ADDENDUM NUMBER 1

PROJECT NAME MILLING AND RESURFACING SR 583 (56th STREET) FROM SOUTH OF EAST 23RD AVENUE TO SOUTH OF EAST FOWLER AVENUE

PLANS REVISION NUMBER 1

LIGHTING DETAILS

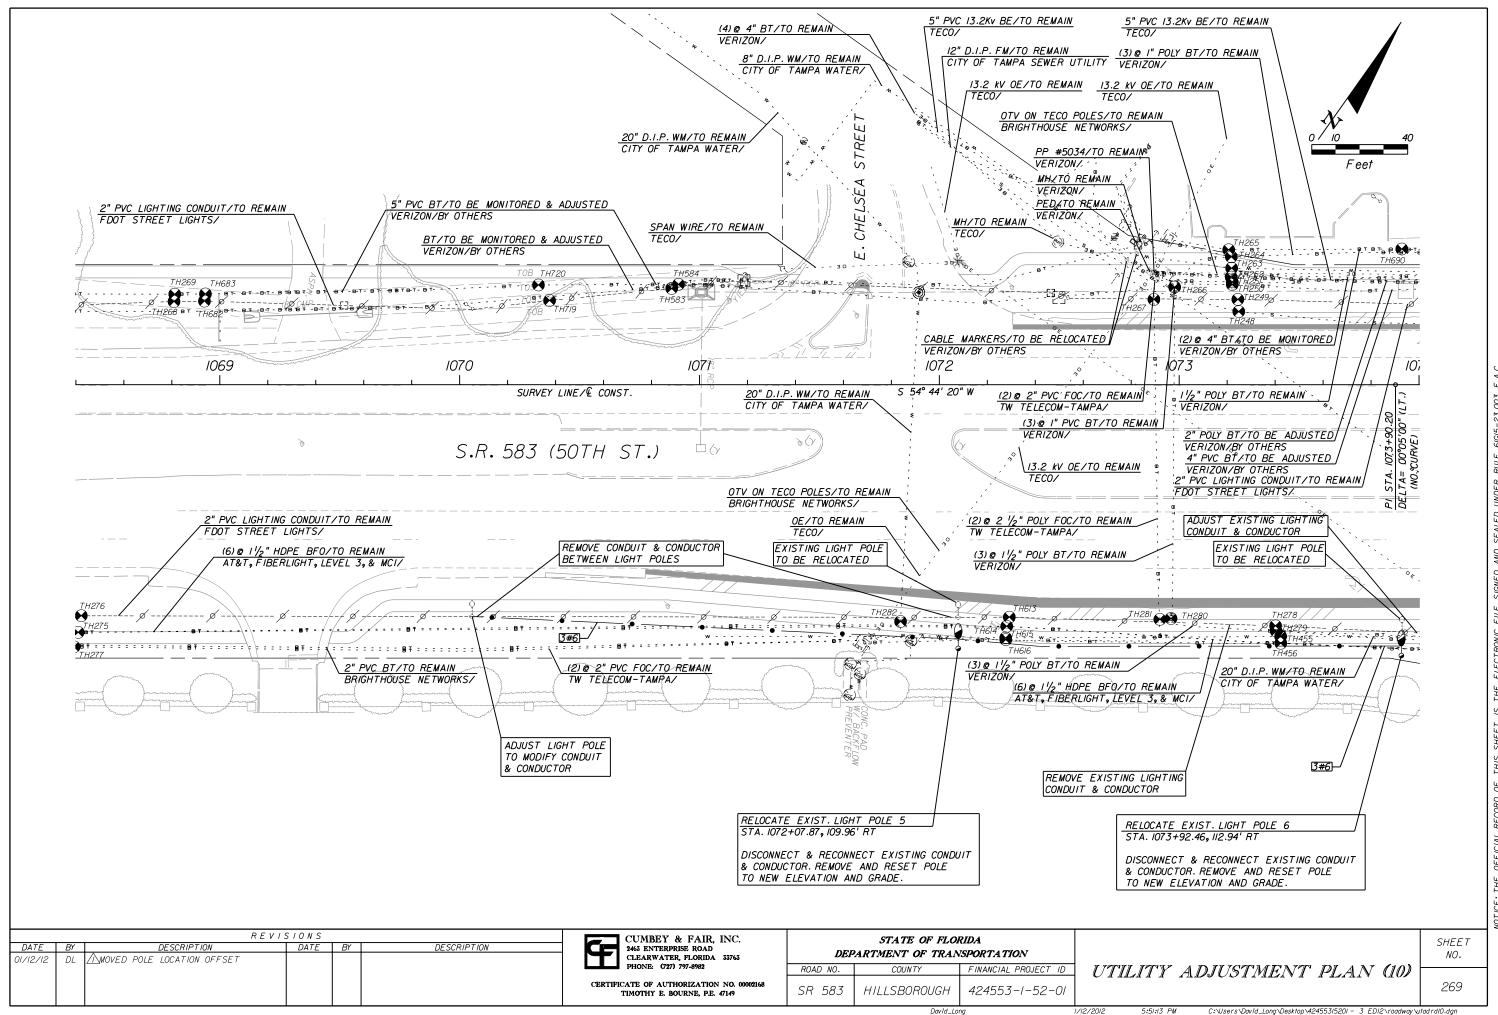
REVI	SIONS		
DATE BY	DESCRIPTION	DATE	BY	DESCRIPTION
OI/12/12 DL AMOVED POLE	LOCATION OFFSET
